# Technical / News Bulletin

TB 0456

<b>Product Group:</b>	Manual Wheelchairs		
<b>Model Affected:</b>	All manual wheelchairs with the option "desk sideguard"		
<b>Effective Date:</b>	Immediate	<b>Serial No. Effective From:</b>	N/A
<b>Bulletin Subject:</b>	Play reduction in desk sideguard

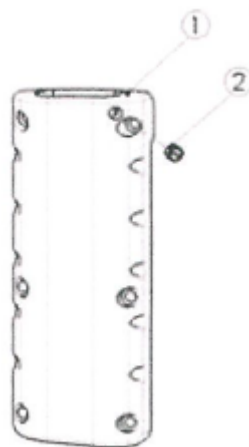
Previously, the armpad of the desk sideguard had too much play.

The nylon screw (2) has been used to minimise the play. It is also adjustable to remove play in the field
